## Discussion Paper – Mainsail Widths

### PROPOSAL FOR A CHANGE IN SAIL RULE OF THE CLASSIC 6-METRE YACHTS

## **Comments from Members of the Technical Committee**

**Appendix: The roach**

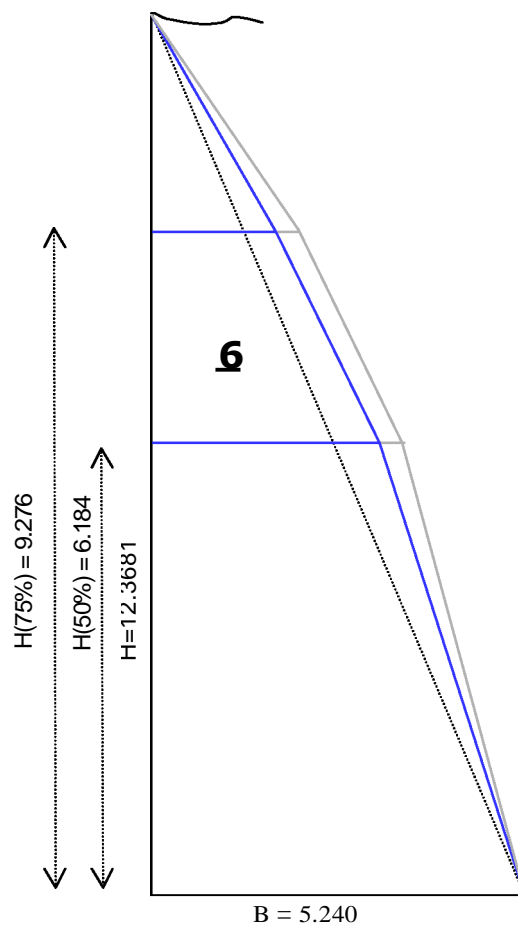
A Classic in its original condition would not tolerate the loads of modern rigs and sails. Practically all Classics, at least all actively raced yachts have been more or less rebuilt and strengthened to conform to the higher loads. Nevertheless, limiting the tensions at the upper end of the wind scale would save the ageing wooden structures. A relatively small decrease in the mainsail area does not deteriorate the sailing characteristics of a Classic yacht. As seen in the example in the Appendix, mainsail would be downsized for about 7 %.

The effect of the [proposal](#) on the roach of a main sail.

Example FIN-61 (T.Holm 1950) with a boom length  $B = 5.240$  m and a luff length  $H = 12.368$  m
